March 1, 2024

Kern County Planning and Natural Resources Department
Attn: Keith Alvidrez, Planner II
2700 “M” Street, Suite 100
Bakersfield, CA 93301
CTV1EIRComments@kerncounty.com
Alvidrezk@kerncounty.com

Re: Comments on the Draft Environmental Impact Report for Carbon TerraVault I

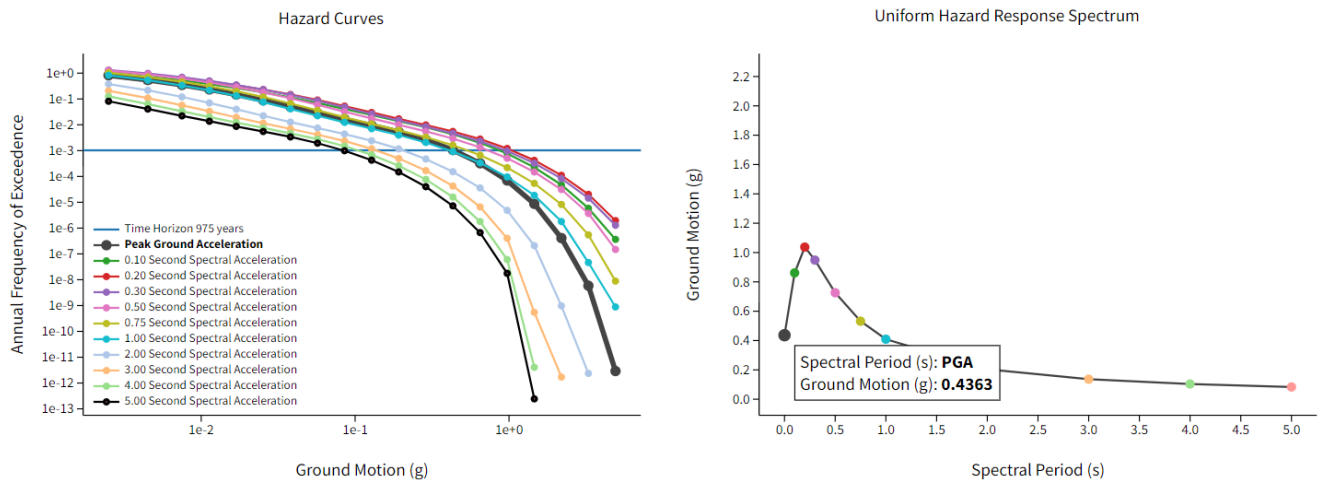
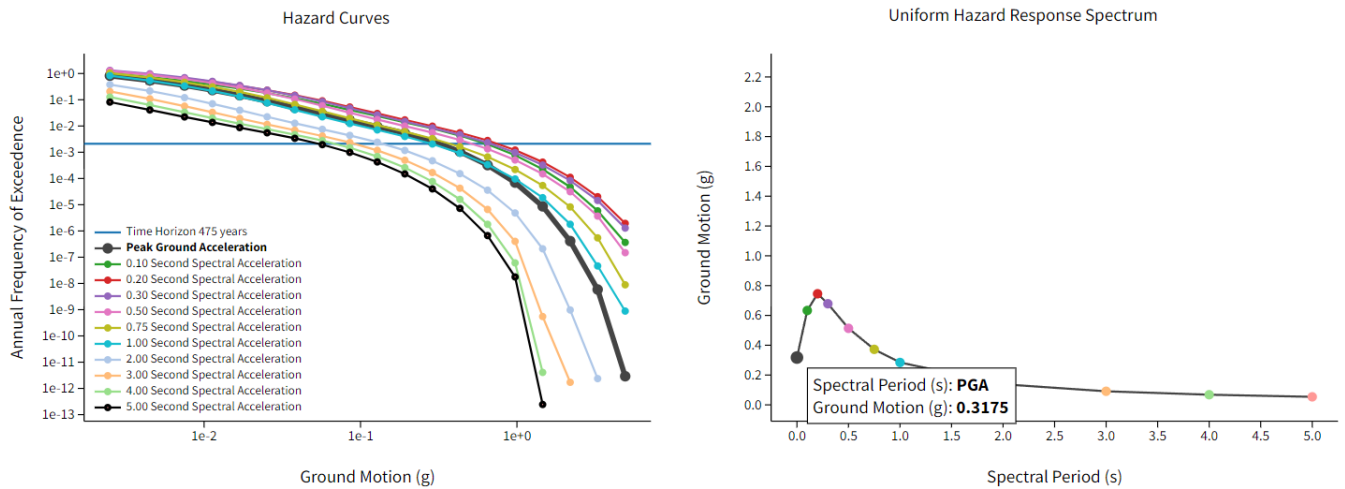
Comment: In Volume 1 of the DEIR, in Impact 4.7-1, it is stated, “an earthquake may disturb surface and/or subsurface facilities, possibly resulting in loss, injury, or death. Impacts from seismic hazards are considered potentially significant without mitigation and MM 4.7-1 would be required to reduce these potential impacts to a less-than-significant level for this individual project impacts.” Mitigation measure 4.7-1 consists of preparing “a comprehensive seismic activity monitoring plan that includes, but is not limited to, connection to the Statewide seismic monitoring program of California Seismic Network (CISN) ... The final plan shall be approved by the California Air Resources Board and include all requirements of State law including but not limited to: Appropriate subsurface monitoring to ensure geologic sequestration of injected carbon dioxide; Identification of hazards and conditions that may require the suspension of carbon dioxide injections; notification protocols for all applicable agencies and emergency procedures. All requirements for seismic monitoring adopted by the California Air Resources Board – Carbon Capture, Removal, Utilization and Storage Program shall be implemented.”

Figure 6. Schematic representation of pressure migration along a high-permeability fault between the Tejon Oil Field and a M 4.6 seismic event along the White Wolf Fault.

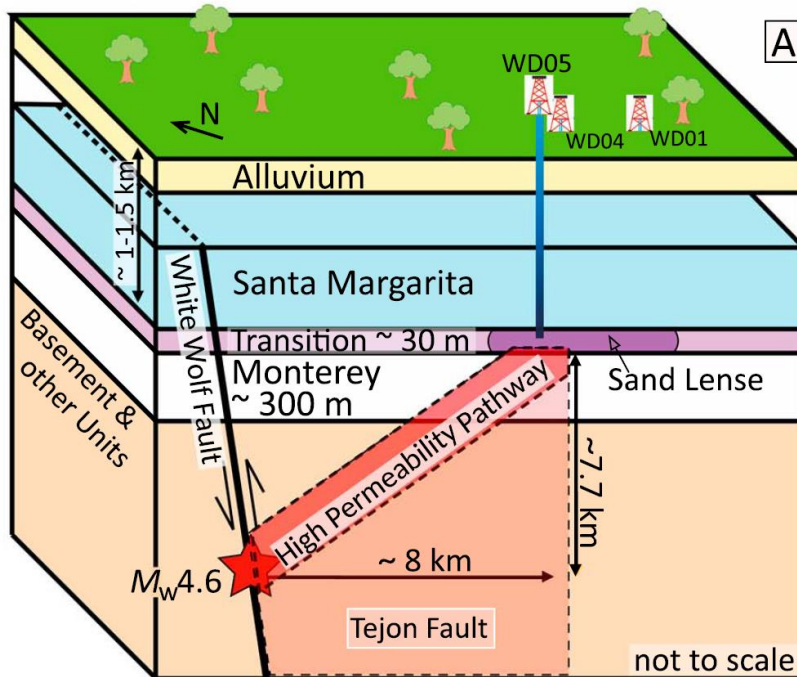
Comment: For induced seismicity, the primary concern here is pressure transmission below the Monterey Formation, not above it. In the Class VI regulations, the primary concern is leakage through faults in the confining layer, not transmission of pressure and induced seismicity below the storage formation. Hence, neither EPA regulations nor the DEIR adequately consider induced seismicity. Callas et al. (2022) state that lack of a lower confining seal (permeability > 100 nD) (nD = nanodarcy) is a disqualifying threshold for geologic storage of CO₂ because of potential pressure propagation to basement rock capable of producing seismic activity. According to schematics provided in Volume 2 of the DEIR, the Reef Ridge Shale bounds both the upper lower Monterey Formation and has an average permeability of 0.01 mD (mD=millidarcy) or 10,000 nD. As discussed, in the 26R and A1 - A2 Storage Areas, CTV states that final pressure will target the initial reservoir pressure at the time of discovery. Hence, this would decrease but not eliminate the possibility of induced seismicity.
